DEVELOPMENT REVIEW COMMITTEE (DRC) COMMENT REPORT

PROJECT NAME: Broward Health Corporate Training Center

CASE NUMBER: UDP-S23046

REQUEST: Site Plan Level II Review: 15,500 Square Foot Office

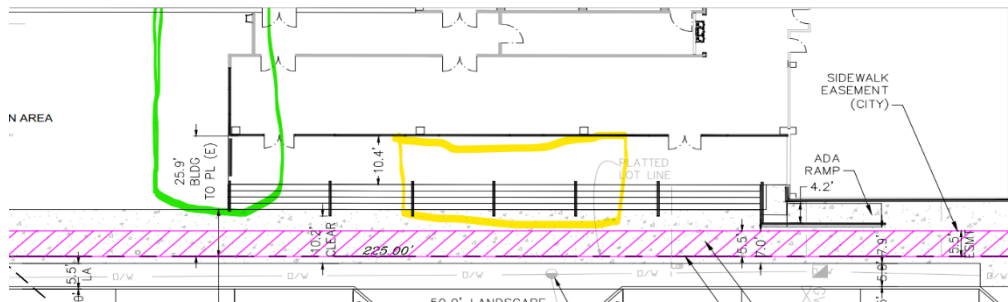
- d. B-4, provide a centralized entranceway or activate the dead space along the frontage with art, seating, or water features, etc. The center of the stairs along SW 1st Avenue (identified in yellow, below) lead pedestrians to a landing without an entrance.

Wrap the stairs around the southern corner of the building's entrance and extend the overhang. These improvements will aid in concealing the blank wall of the auditorium, provide additional articulation, activate of an unused corner, and rounds out the aesthetics of the entranceway.

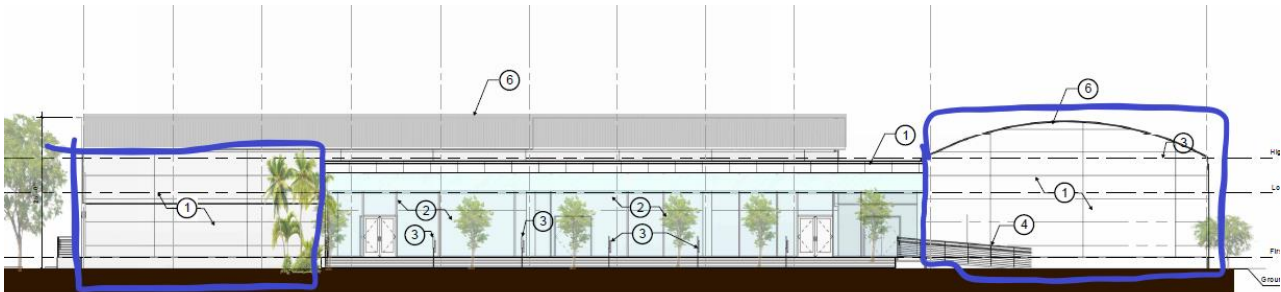
- e. B-17, the plans show low and high roof measurements on the east facade, but the height of the entrance seems higher than what is labeled. Update plans to reflect the proper height and clarify if the clerestory windows above the front entrance are frosted glass, and if so, add the material to the elevation material list.

NEW EAST ELEVATION
 3/16" = 1'-0"

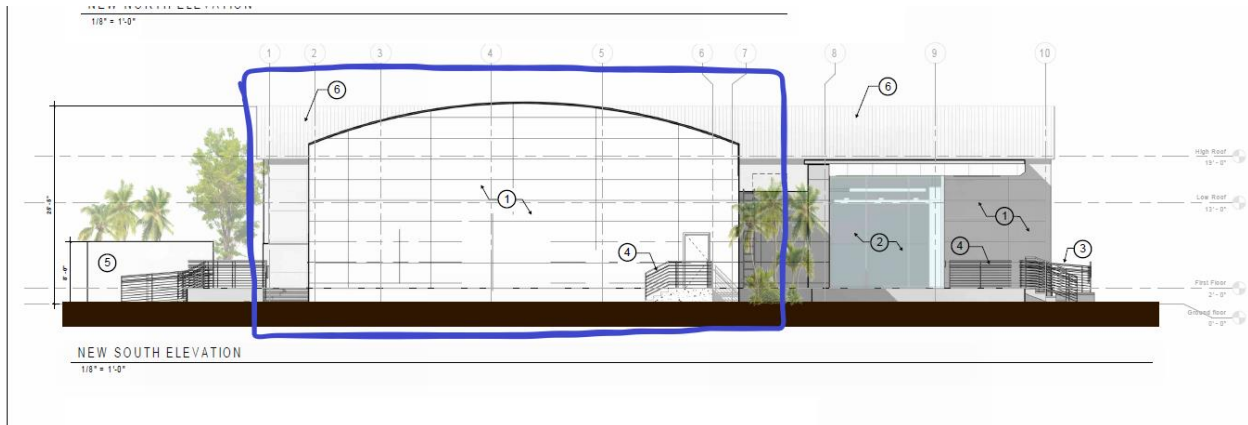
13. Provide the following changes on elevations:
 - a. Provide windows on the east and south facades to provide transparency and break up the large blank walls and improve the pedestrian experience.
